Report: ISSUES

Function: Test, Adjust, & Balance

Forge HQ (Kansas City, MO)

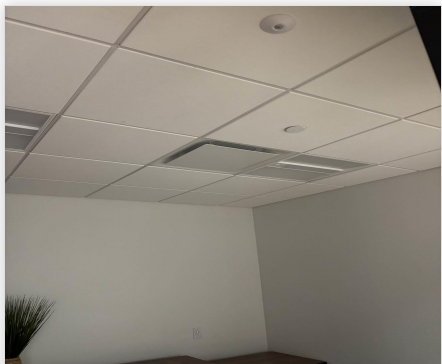
Issue Name : FCU-2: Broken Damper Handle
Description : The damper handle is broken. Proper Airflow could not be set.
Created By : National TAB **Assigned To :** National TAB - Kalen Kemp
Status : Open
Priority : Urgent **Asset Tag :** F2-2
Originated Date : 09/24/2025 - Kalen Kemp - National TAB

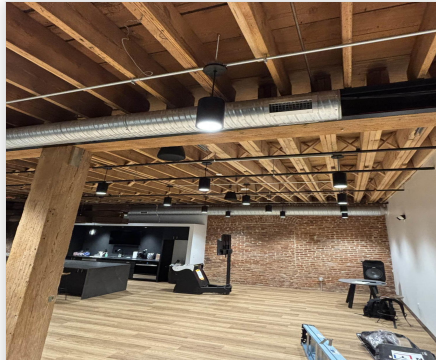
Issue Name : FCU-2: Missing Damper
Description : The damper for the office diffuser is missing. Could not set airflow to proper amount.
Created By : National TAB **Assigned To :** National TAB - Kalen Kemp
Status : Open
Priority : Urgent **Asset Tag :** F2-9
Originated Date : 09/24/2025 - Kalen Kemp - National TAB
